EXHIBIT A

**Attached to Conservation Groups'
May 27, 2011 Public Comment Letter
Submitted in EIB 11-01 (R) and EIB 11-02 (R)**

Re: New Mexico Environment Department, Air Quality Bureau May 3, 2011 Public Meeting in Farmington on the proposed Regional Haze state implementation plan revisions and proposed revisions to the good neighbor provisions of New Mexico's infrastructure state implementation plan. The New Mexico revisions include a determination of Best Available Retrofit Technology for San Juan Generating Station.

Dr. Sahu has prepared a May 1, 2011 Brief Critique of San Juan Units 1-4 Proposed NOx BART Proposal for NOx Reduction Using Selective Non-Catalytic Reduction (SNCR) with the following 10 points:

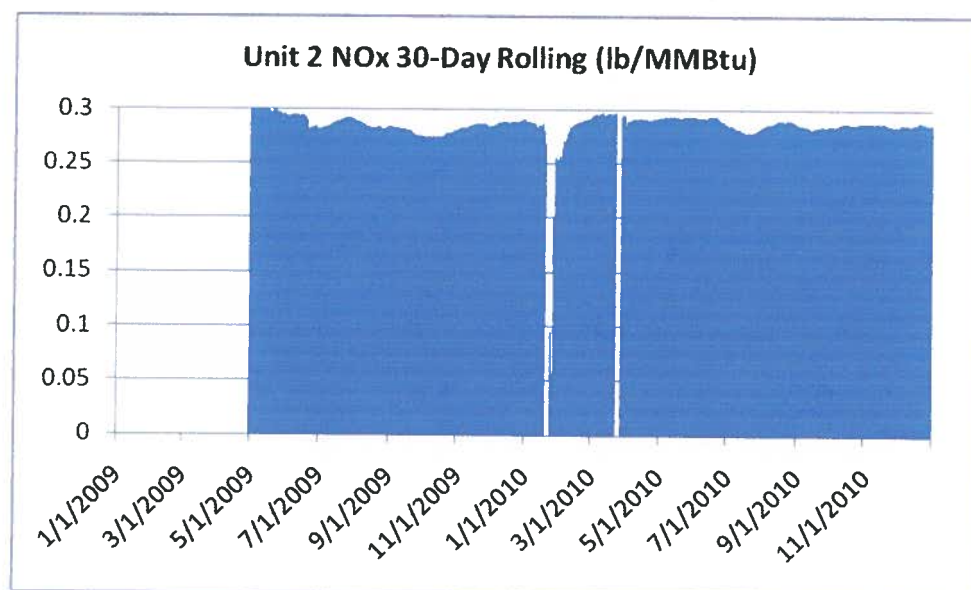
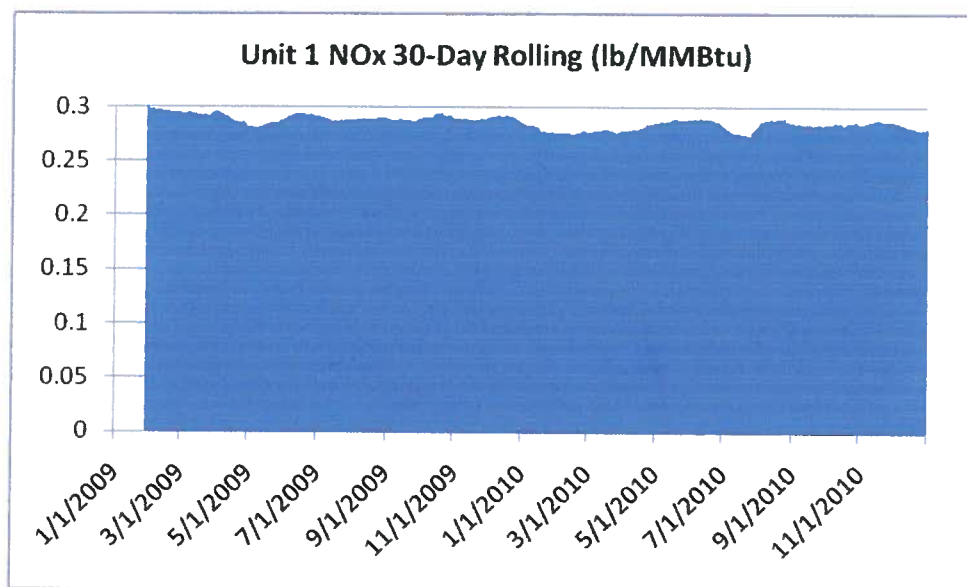
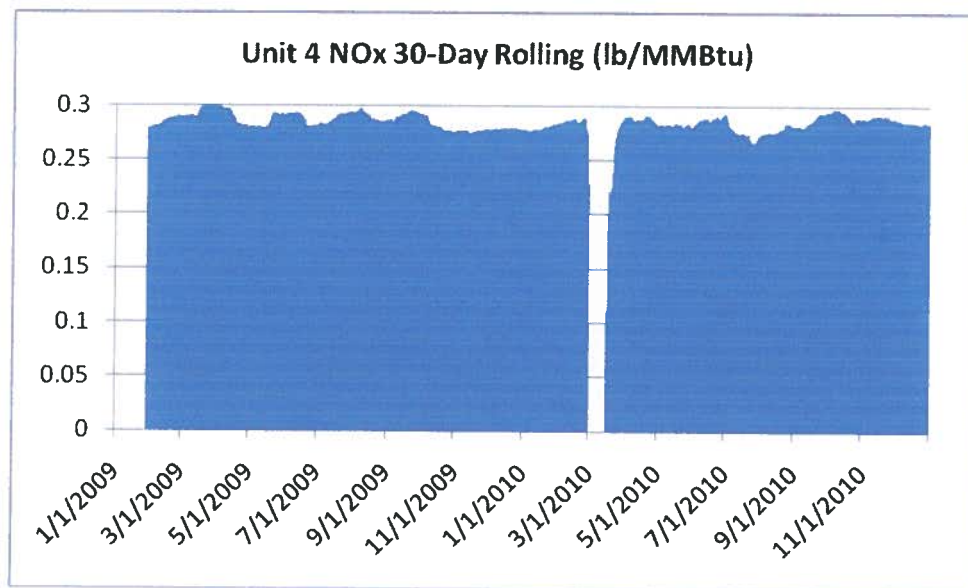
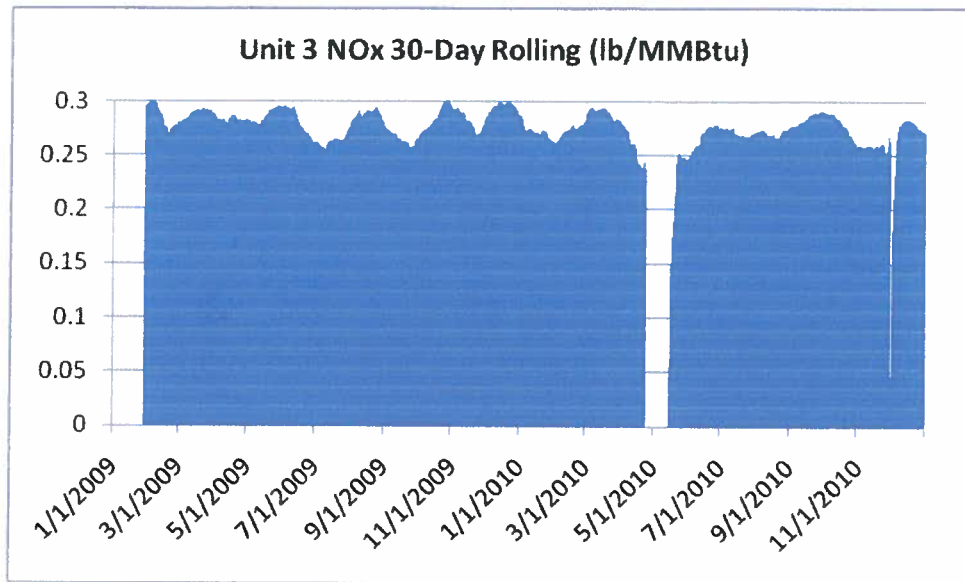
In addition, the figures below show the 30-day rolling average data for each unit.

Based on the above, it is clear that: (a) for each unit, the average of the 30-day rolling average NOx did not exceed 0.29 lb/MMBtu; and (b) while there is expected variability in the 30-day rolling average values, this variability is not excessive. For example, the ratio of the maximum (of the 30-day rolling average values) to the average, is below 12% is all units. It ranges from a low of 4.7% for Unit 1 to a high of 11.1% for Unit 2. For purposes of this discussion, I will
